Access Compliance Report Public Rights-of-Way (Curb Ramps)

Main Street: ROCKAWAY_DR Cross Street: ROXBOROUGH_DR Location: NW

ADA ID: RPAT210917090446 Ramp Type: Type 1 - Perpendicular Diagonal Initial Pass/Fail: Pass Overall Compliance: No Severity Score: 4

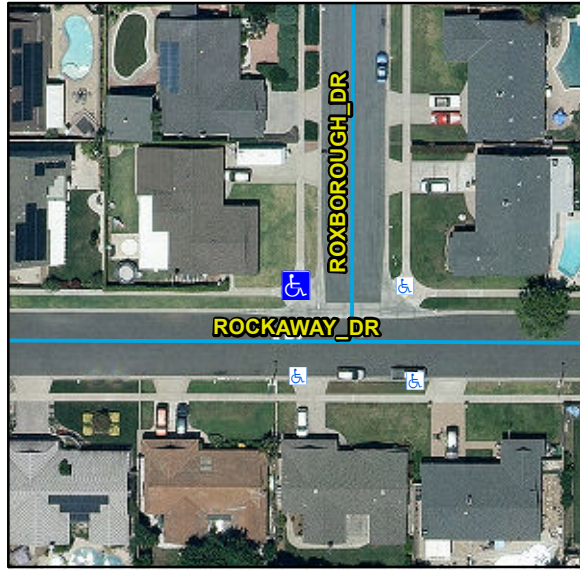
R304.2.2, R304.2.1, STD 1115

Remove & Replace Curb Ramp With Two New Directional Ramps or Equivalent.
